Access Compliance Report

Public Rights-of-Way

(Curb Ramps)

Intersection ID: 13249	Main Street: E_PALMER_ST	Cross Street: S_COLLEGE_ST	Location: S
ADA ID: CFB354B53212	Ramp Type: PerpDiag	Initial Pass/Fail: Fail	Overall Compliance: No
			Severity Score: 46.25

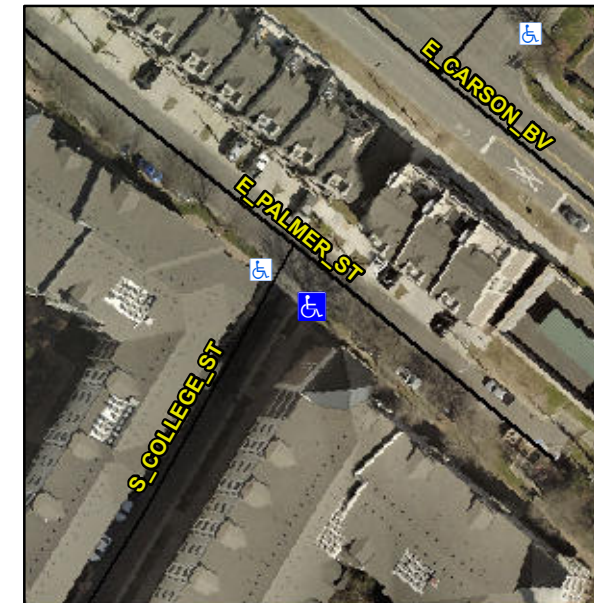
Not Found, R304.5.1, R304.2.2, R304.5.3

Compliance	Description	Data	Compliance	Description	Data
N/A	Ramp Length (in)	48.0	No	Ramp Slope (%)	10.9
No	Ramp Width (in)	43.0	No	Ramp XSlope (%)	7.2
N/A	Flare Type LT	N/A	N/A	Flare Type RT	N/A
N/A	Flare Slope LT (%)	N/A	N/A	Flare Slope RT (%)	N/A
N/A	Flare Traversable LT?	N/A	N/A	Flare Traversable RT?	N/A
N/A	Landing Length (in)	N/A	N/A	DWS Provided?	N/A
N/A	Landing Width (in)	N/A	N/A	DWS Contrast?	N/A
N/A	Landing Slope (%)	N/A	N/A	DWS Length (in)	N/A
N/A	Landing X Slope (%)	N/A	N/A	DWS Full Width?	N/A
N/A	Landing Curb? (Y/N)	N/A	N/A	DWS Offset (in)	N/A
N/A	Shared Landing?	N/A			
N/A	Gutter Ponding?	N/A	N/A	Gutter Slope (%)	N/A
N/A	Gutter Lip Ht (in)	N/A	N/A	Gutter X Slope (%)	N/A
N/A	Painted X Walk1?	No	N/A	Painted X Walk2?	No
	X Walk 1 Direction	To NE		X Walk 2 Direction	To NW
N/A	X Walk 1 Width (in)	N/A	N/A	X Walk 2 Width (in)	N/A
	X Walk 1 Slope (%)	1.5		X Walk 2 Slope (%)	3.2
	X Walk 1 X Slope (%)	3.7		X Walk 2 X Slope (%)	4.3

Remove & Replace Curb Ramp With Two New Directional Ramps or Equivalent.
